Addendum Number One

To The Drawings and Specifications for:
Sedgwick County Park – ADA Improvements (RFP#16-0077)
6501 W. 21st Street North
Wichita, KS 67205

HANNEY & ASSOCIATES ARCHITECTS

2.1 Sheet SP-1:

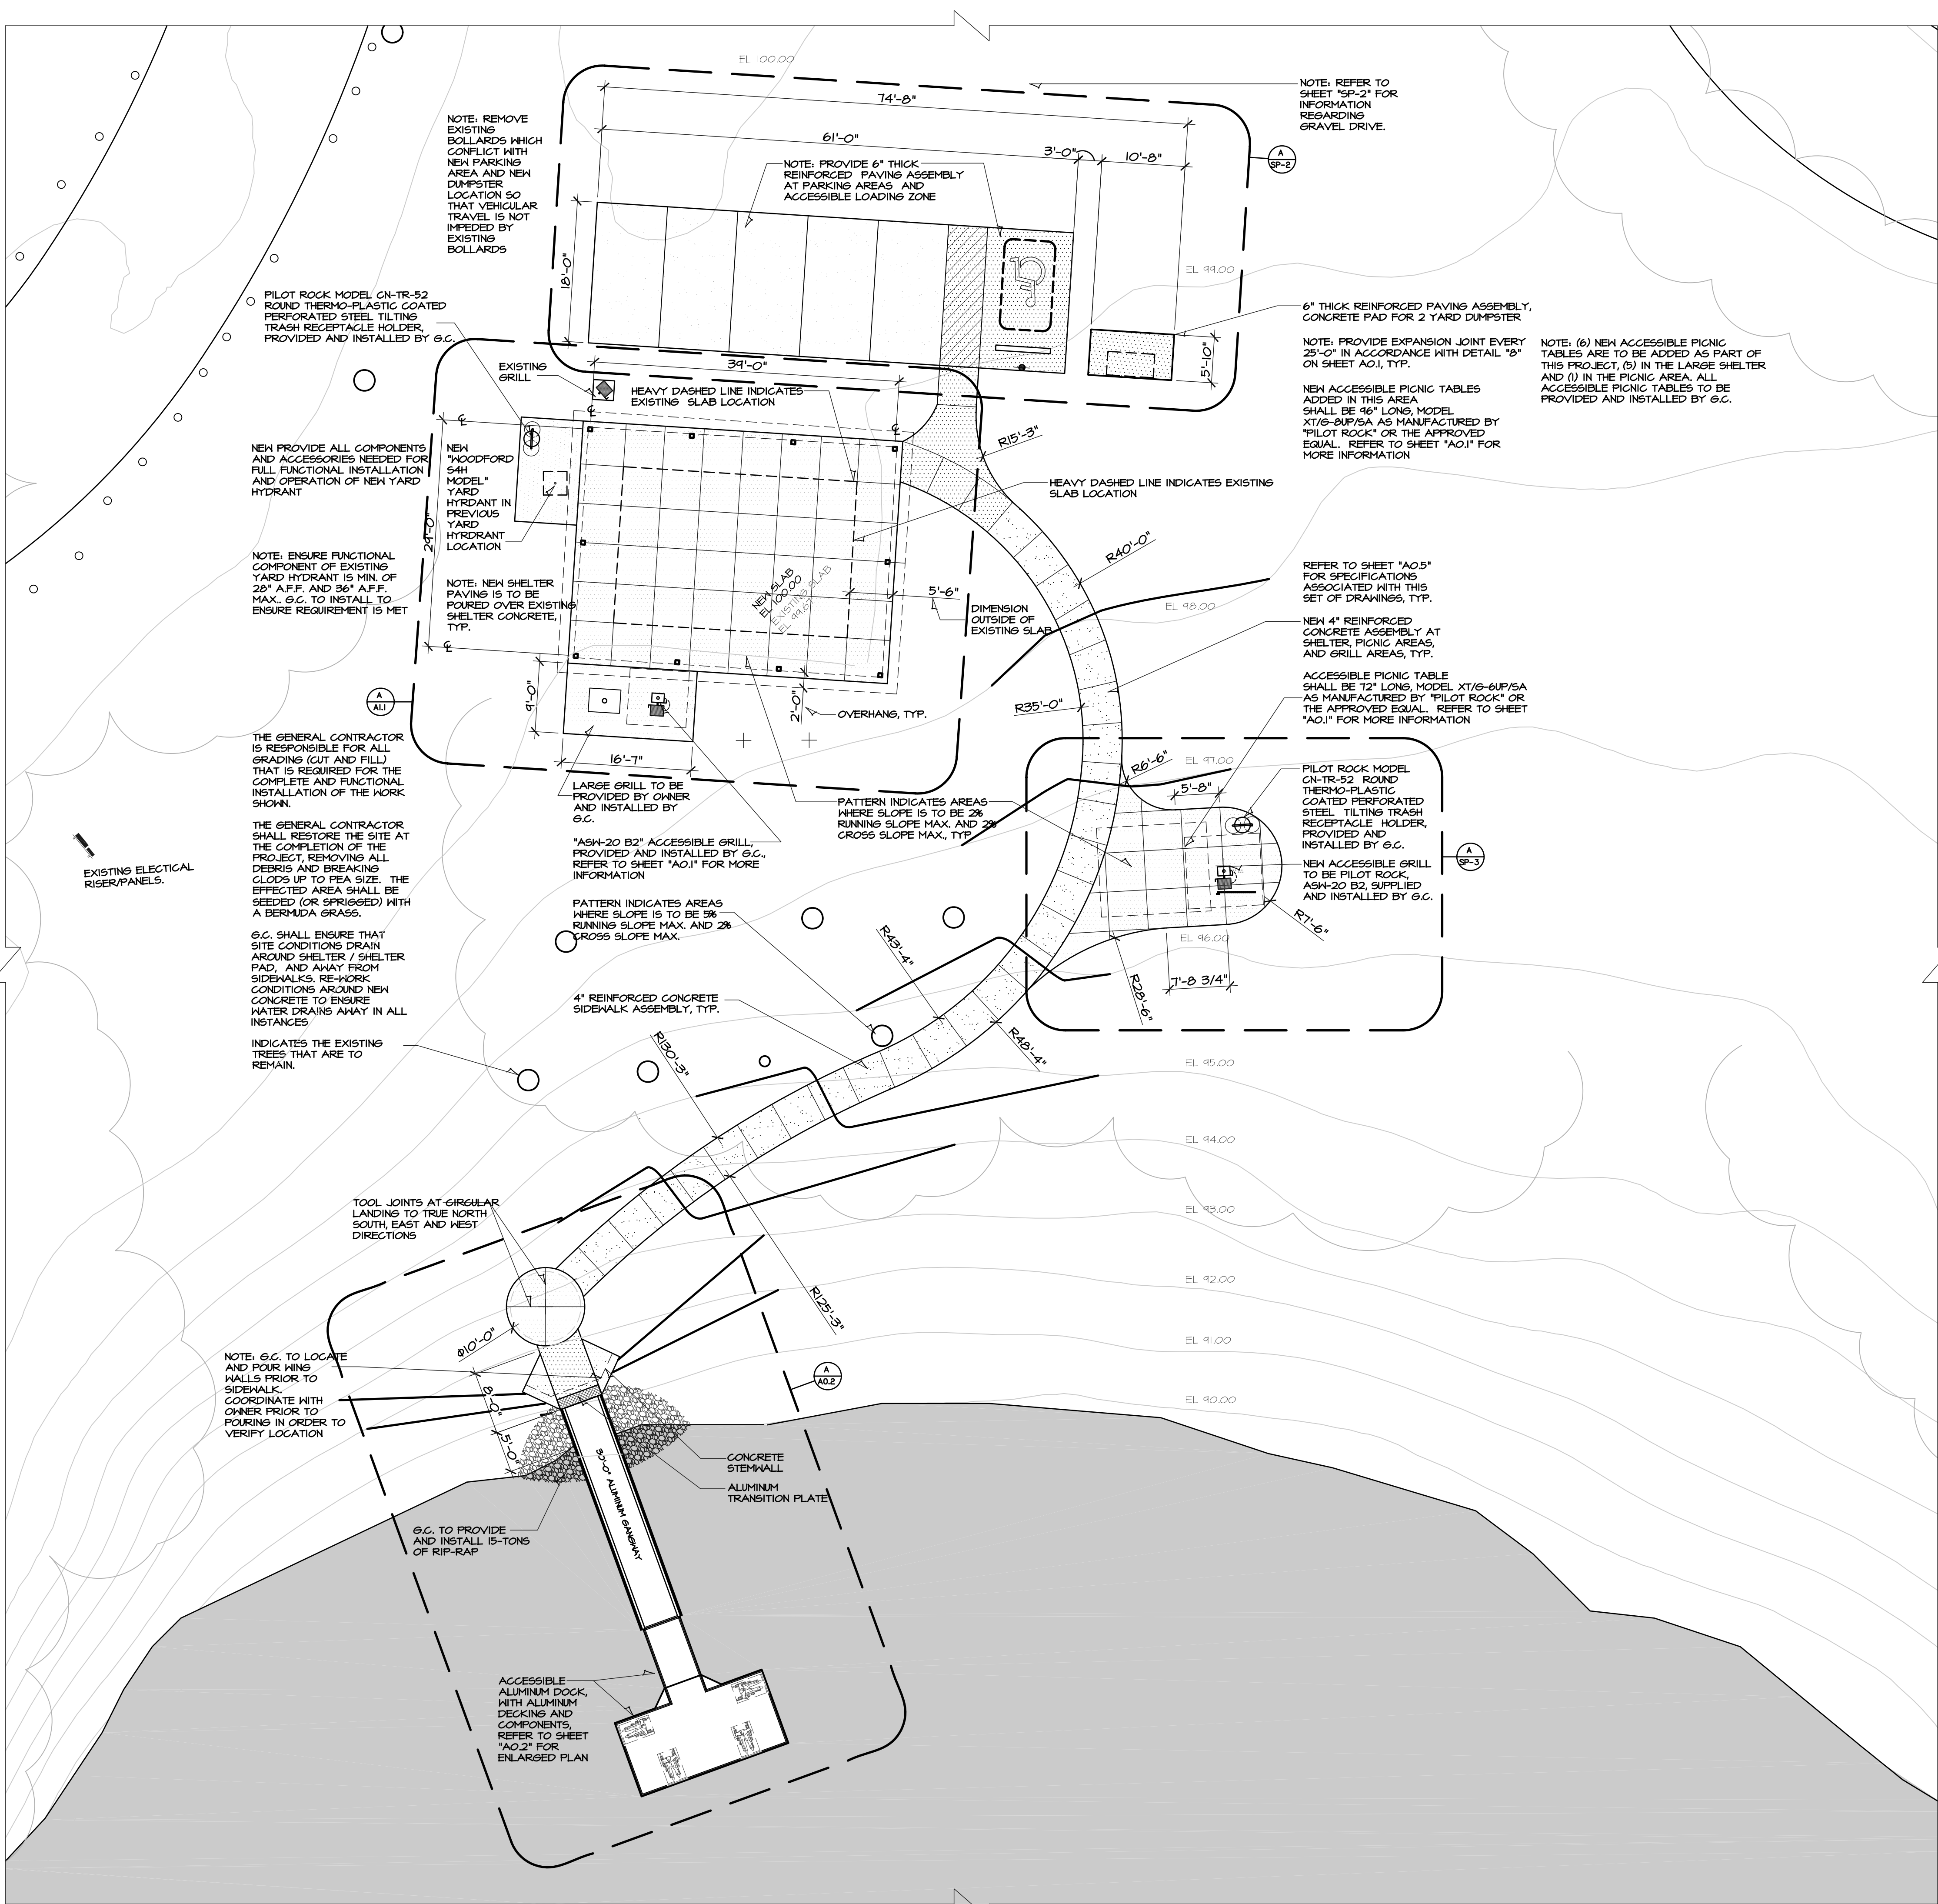
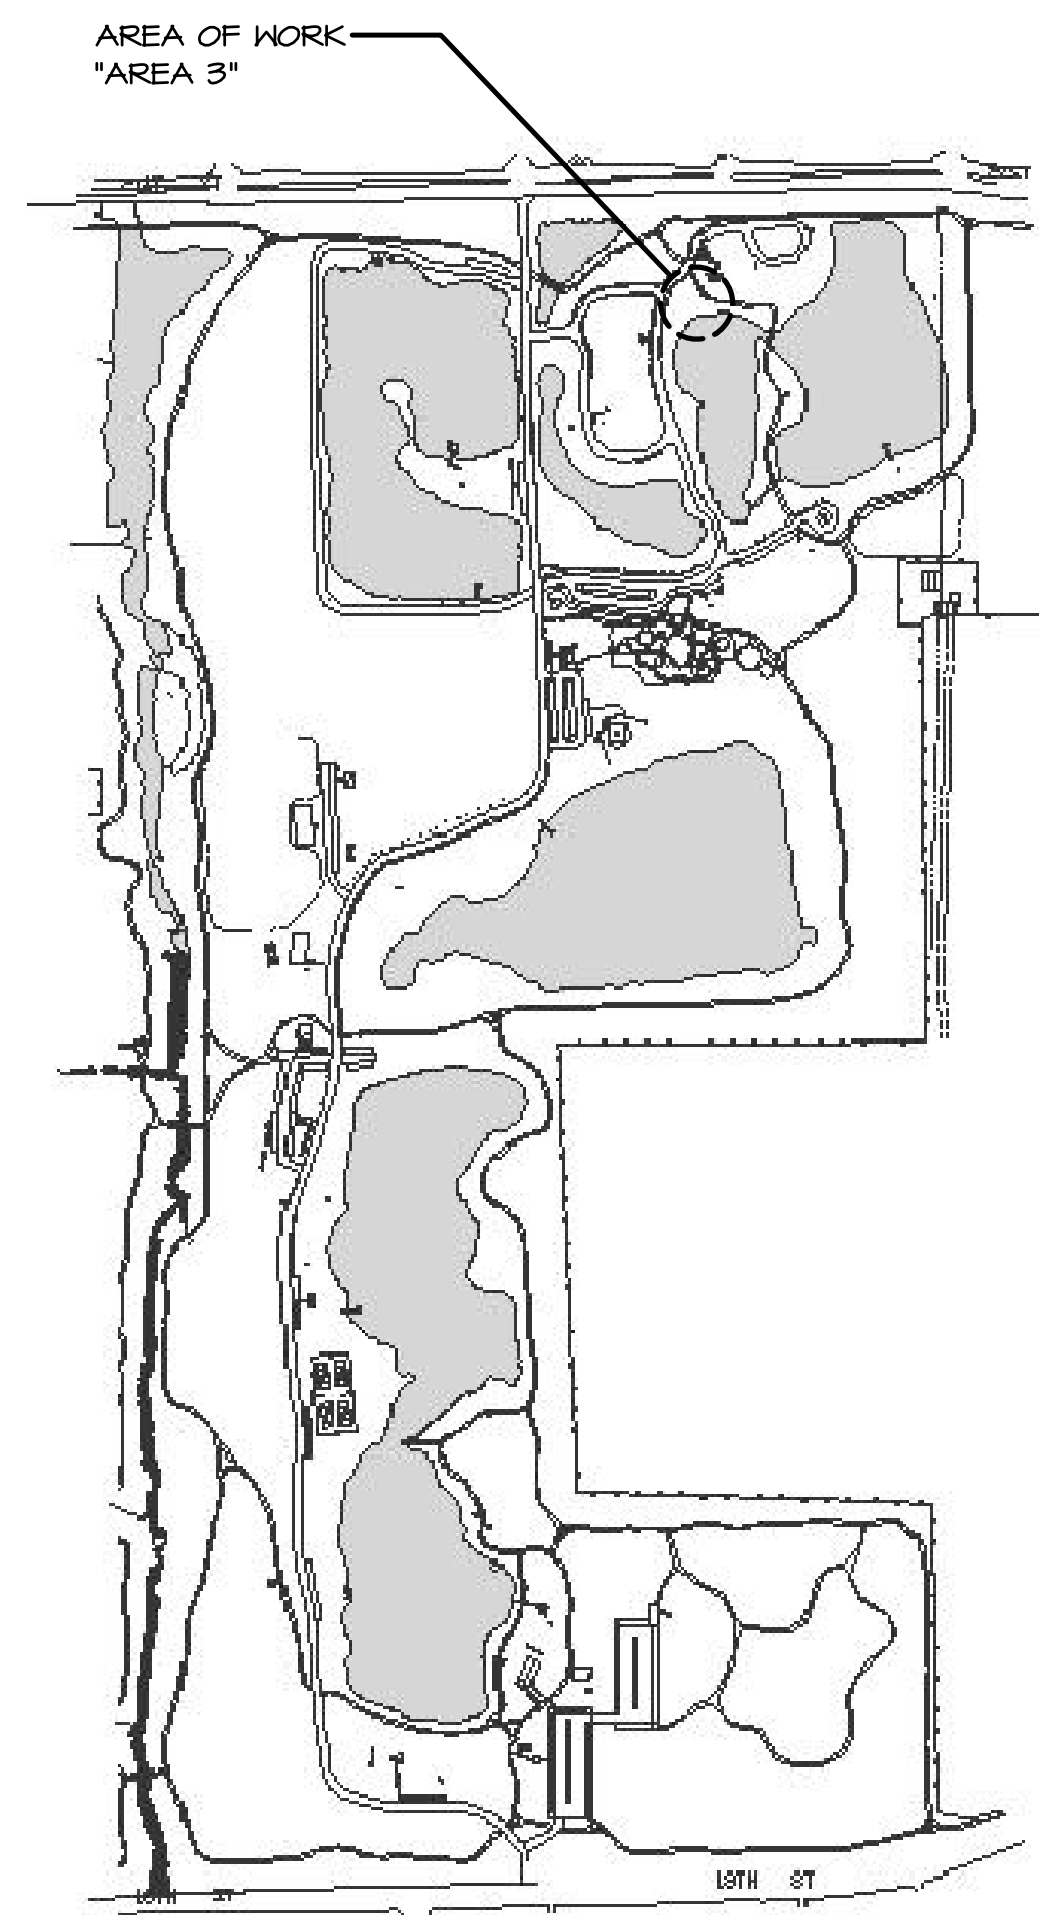
- 1.1 The Bid Date and Time shall remain unchanged.
- 1.2 Lake Elevation:
The lake elevation is currently at standard pool. The new gangway head wall shall be located 5'-0" from the current waters edge.
- 1.3 Benchmark:
 - a. The benchmark will be the existing concrete slab from the previous shelter. It is assumed that this slab is at elevation 99.60. The General Contractor shall include in their base bid time to shoot in the elevations of the site to verify the conditions shown on the plans.
 - b. The gangway headwall shall be located approximately 5'-0" away from the current water line.
 - c. The elevation of the water line is assumed to be 89'-6" as shown on SP-1.

- 1.8 Location of trees:
The new sidewalk is planned to go between the existing trees. No tree removal will be required with this project. Sheet SP-1 is being re-issued with this addendum to show the locations of the trees.

- a. The note at the top of the site plan refers to the gravel drive (as shown on sheet SP-2) is “future”. The word “future” shall be deleted. This work will be completed with this project.
- b. This sheet is being re-issued with this addendum in order to show the rip-rap and existing tree locations.
- c. The new 4” thick, reinforced concrete slab pours over the top of the existing concrete slab. The existing concrete slab is at elevation 99.60, which shall function as the bench mark for this project. We have two fixed points to work with – this existing slab elevation and the water level.
- d. The General Contractor shall use barrow as required to adjust the final grades to be compliant with the ADA.
